NOTICE OF URBAN PLANNING COMMITTEE MEETING

Planning Reforms - Response to P&D Code Consultation

Planning and Design Code (Phase 3) Consultation – City of Marion Formal Response

Marion Council Submission on the Draft
Planning & Design Code – February 2020

Industry Zone, Precinct 4 Industry Interface to Suburban Employment Zone

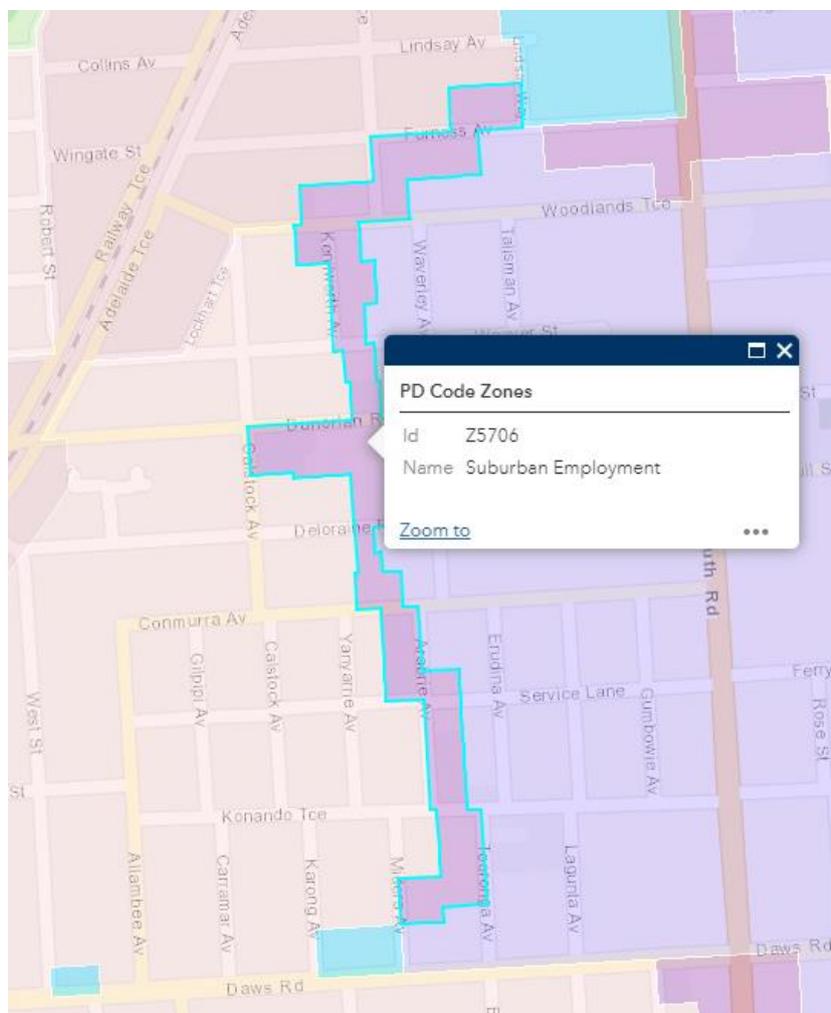
- The current Precinct 4 Industry Interface should be a 'sub-zone' of the Suburban Employment Zone which incorporates the protection currently provided by the existing Development Plan.

Area highlighted in blue is the current Interface

Industry Zone, Winery Policy Area 8 to Suburban Employment Zone

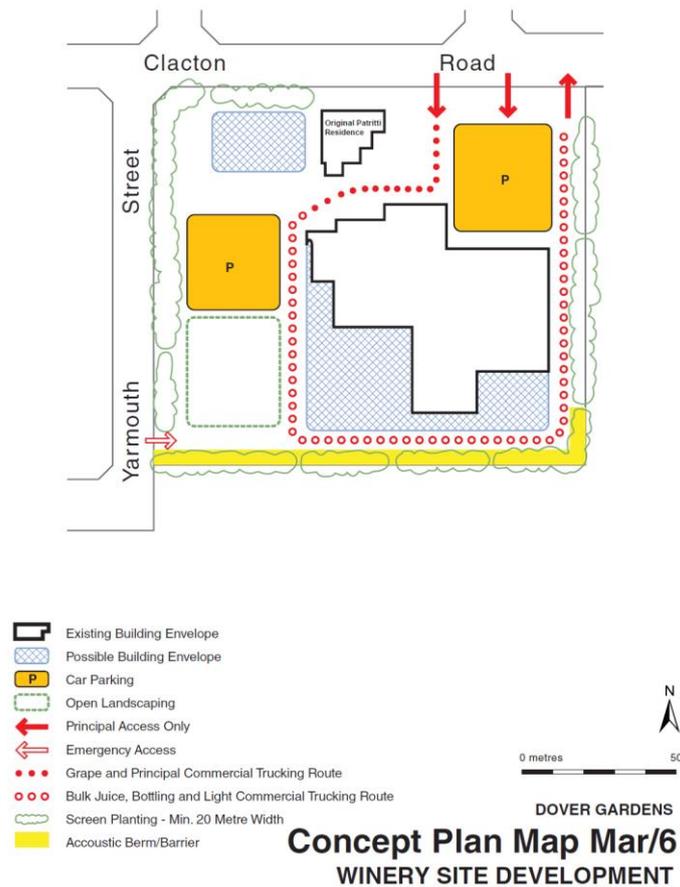
- The current Winery Policy Area 8 contains specific Principles of Development Control that's limits the type (i.e. buildings for Winery and ancillary related purposes) and intensity of the use, and provides guidance on the desired built form outcomes. Suburban Employment Zone does not provide specific restrictions on the type of use and likely built form outcomes.

- Give the small scale nature of the Policy Area (a single allotment), Council is of the opinion the current Winery Policy Area 8 should be a 'sub-zone' of the Suburban Employment Zone which incorporates restrictions on future use and the desired built form outcome currently provided by the existing Development Plan. Additionally, the existing Winery Site Development (Dover Gardens) Concept Plan should be included as a *Concept Plans Technical and Numeric Variation Overlay*.

Spatial Map Zone and Overlay Issues

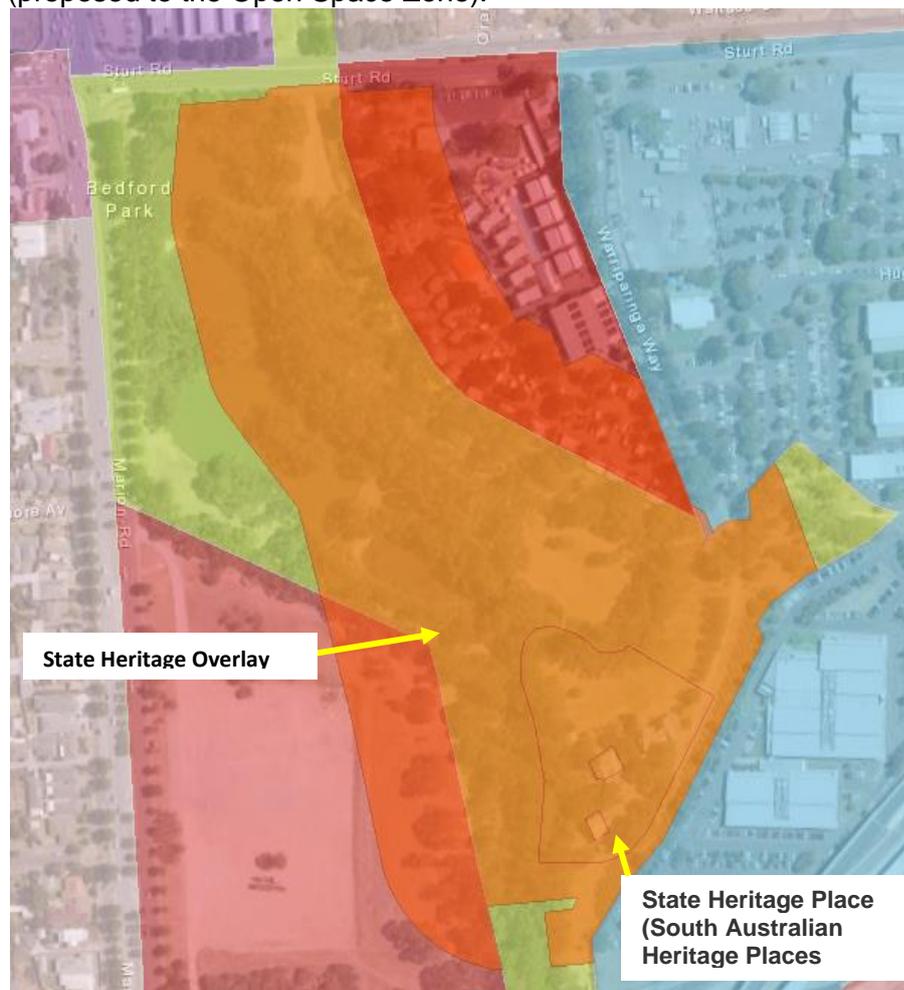
- The State Heritage Place Overlay contained within the Planning & Design Code is larger than the current allotment where the Heritage Places are contained. Located at the Sturt Triangle, Sturt, the State Heritage Place (as prescribed in the Development Plan and SA Heritage Database) includes Warriparinga wetlands, including Fairford House (Laffer Residence), Coach House (former winery) and surrounding grounds.

The State Heritage Place Overlay encompasses not only the Open Space Zone where the Heritage Places are located, but also sections of the Caravan and Tourist Park Zone (in dark red) and the Urban Neighbourhood Zone (in light red).

Clarification Required

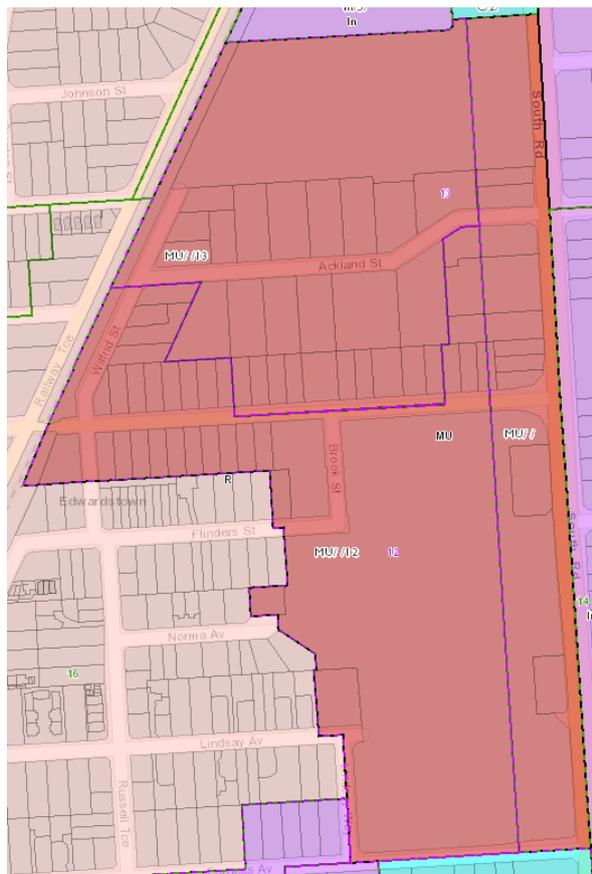
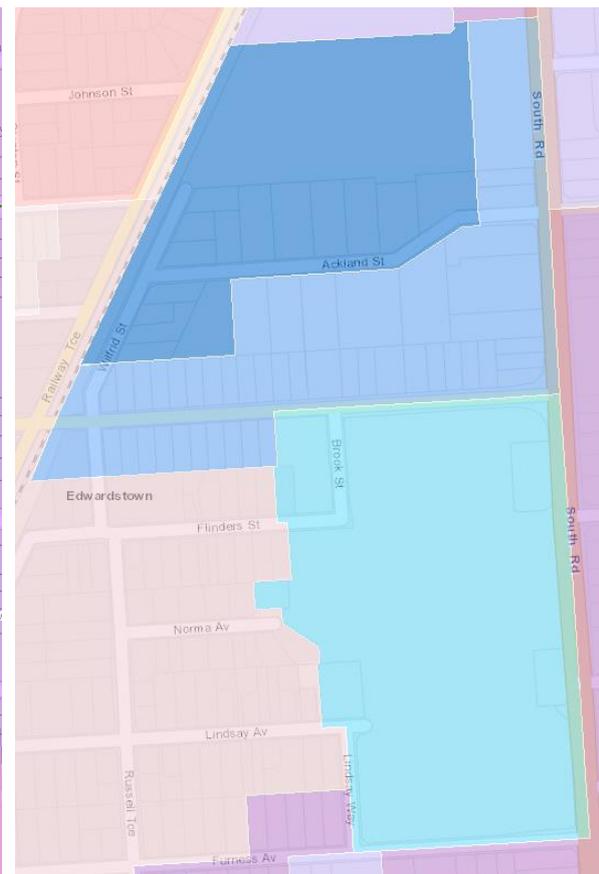
- The proposed spatial mapping boundaries provided as part of the P&D Code for the new Zones at Castle Plaza are not consistent with the existing Precinct boundaries illustrated within the Development Plan.

- Council seeks clarification as to how the spatial overlay has been developed and implemented. Additionally, clarification is required on why the State Heritage Listed Area Overlay exceeds the existing allotment boundary which contains the Heritage Places (proposed to the Open Space Zone).

Existing Development Plan Zoning
 Red = Mixed Use Zone
 Blue Line = Precinct and Area boundary

Planning & Design Code Zoning
 Teal = Suburban Activity Centre
 Light Blue = Suburban Main Street
 Dark Blue = Suburban Business and Innovation
